SERVICE BULLETIN

TS-430S 500KHZ Hetrodyne

3.23.83

Figure 1

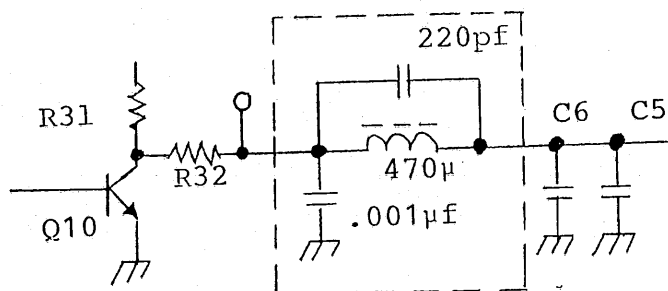
1. Remove top and bottom covers.
2. Turn radio bottom up and locate PLL Unit (X50-1910-00).
3. Remove the six (6) screws securing the PLL unit to the chassis and fold the unit over, to allow access to the foil side of the circuit board.
4. Remove the jumper wire that is installed between TP-1 and C6. Install the parallel circuit consisting of the 220pf capacitor and the 470 μ h coil in its place. See figure 2.
5. Install the .001 μ f capacitor as shown in figure 2.
6. Reinstall the PLL unit and replace the top and bottom covers.
7. No alignment is required.
